Computer Systems Division
 9740 IRVINE BOULEVARD
 P.O. BOX 19724
 IRVINE, CALIFORNIA 92623-9724
 TELEPHONE: (714) 583-3000
 TELEX: 183-812 (Toshiba IRVN)

Issue Alert Letter #24

CD-ROM Assembly

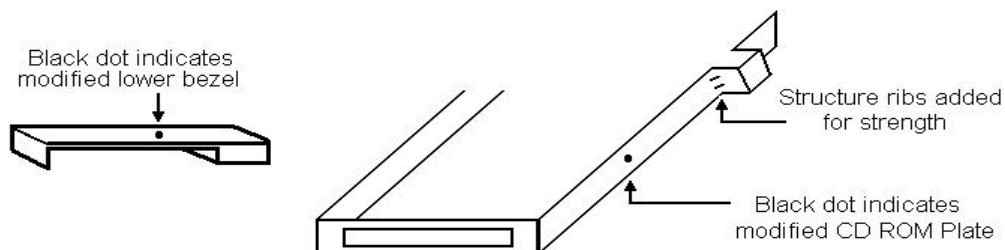
Improvements were made to the Select Bay and CD-ROM assembly in November correcting the problem on systems with serial numbers greater than 116xxxxx.

To see if the CD-ROM drive has been modified, look for the structure ribs which have been added to the cam bend in the new version of the CD-ROM Plate as shown in the illustration below. Additionally, the black dots, also shown in the illustration, should be added in indelible ink whenever a CD-ROM drive assembly is modified by a Service Provider.

Remove the lower bezel by pulling the upper bezel slightly away from the assembly, thus releasing the lower bezel. Once removed be sure that any remaining adhesive tape is removed from the base of the CD-ROM drive. Remove the paper strip exposing the adhesive tape provided on the inside of the new lower bezel and install it on the assembly. Remove the original CD-ROM plate and replace it with the modified part. Mark the new components as shown above.

Field Modification Procedure for the Select Bay Assembly:

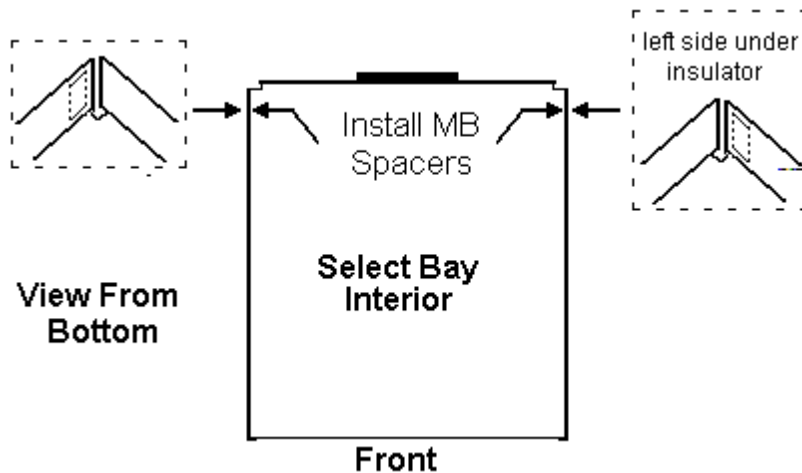
Attach the two new mylar spacers along the back corner of each side in the Select Bay Frame as illustrated below. The long side of the rectangular spacers should be positioned vertically from the top of the Select Bay to about 1/4" from the bottom edge. Keep in mind that access to the inside of the Select Bay is from the bottom.

Replace the original Lock Hook with the modified part, carefully replacing the spring between the Lock Hook and base. Replace the System board and Select Bay Frame into the base ensuring that the Lock Hook is fitted up through the appropriate slot in the Frame. Be sure that the Lock Hook slides freely and is spring loaded into the locked position. Reassemble the system and test. Make sure that the CD-ROM drive will seat and latch properly into the Select Bay.
